ENGINEERING NOTIFICATION

DESCRIPTION : SLIDE SWITCH

MODEL NO. : IS-2235-G

BPM No. : SA45_108121002

Old Type (舊產品)	New Type (新標準品)

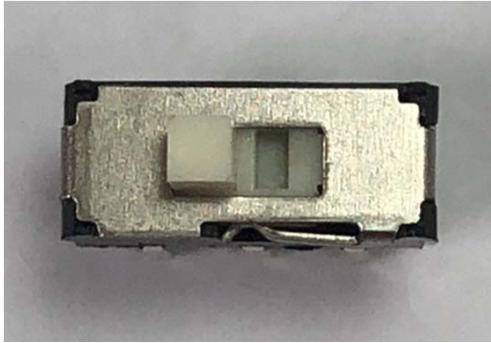
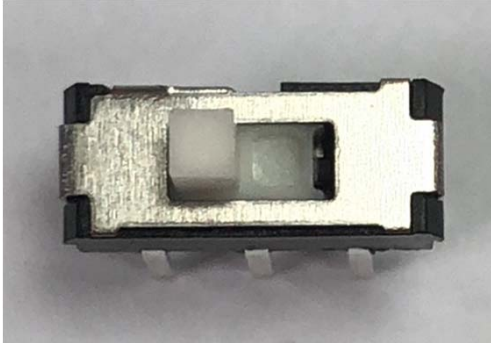
1. Cause (變更原因) :
Tooling improvement.
年度模具改善。

As using the same tooling injection, the product size is the same as before.
Enhance slide feeling while switching position.
使用相同模具注塑，尺寸相同，改善撥柄段落感。

3. Switronic Effective Date (一綺變更起始日期) :
Effectived from Oct. 01, 2019
自 2019.10.01 起變更生效。

4. Quality Guarantee (品質保證) :
The function, soldering status and quality will be exactly the same as before.
我們保證其功能、焊接能力和品質和以前相同。
